To: Chair and Members of Rothesay Planning Advisory Committee
From: Brian L. White, MCIP, RPP
 Director of Planning and Development Services
Date: Friday, February 04, 2022
Subject: Rezoning - 40 Unit Apartment Building – (Highland Avenue & Hillcrest Drive)

Staff recommend that PAC consider removing from the Table an application to rezone land off Highland Avenue and Hillcrest Drive from Single Family Residential – Large Serviced Zone [R1a] to the Multi-Unit Residential Zone [R4]) subject to a development agreement.

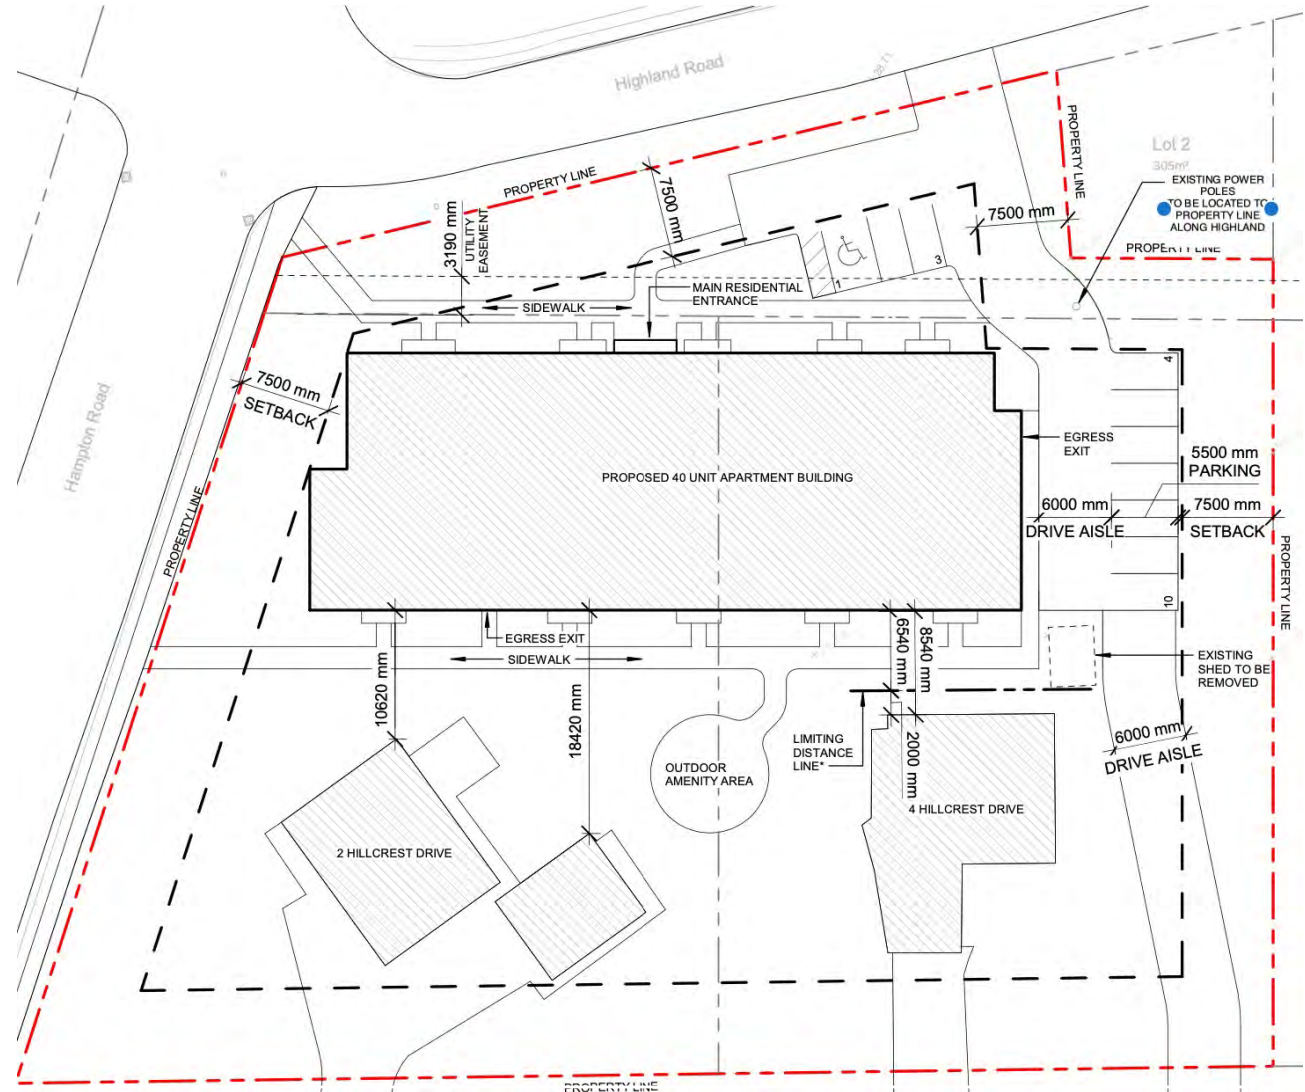
We engaged our Architecture consultants to redesign the roof line architecture of the building. This may reduce unit sizes on the top floor. The roof was redesigned as a Mansard Style Roof with secondary and minor roof lines. The redesign also includes dormers and peaks to help break up and reduce the apparent mass of the roof and the building. These were key elements or suggestions from town staff to our architect. Our architects also took inspiration from a building in Halifax that was recommended by Town Staff in evaluating rooflines.

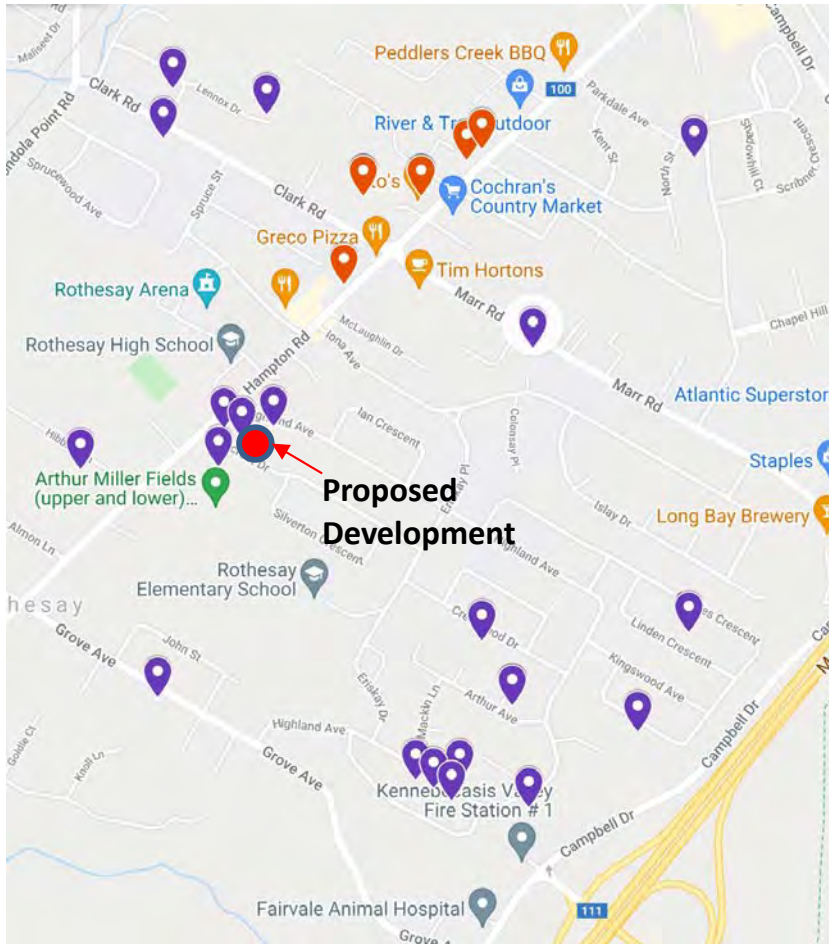
A Flat roof improves the sustainability initiative of utilizing solar power.

For a town that supports recycling and having brown paper bags in support of the environment – having a flat roof to help reduce carbon emissions was viewed as a positive in our planning process.
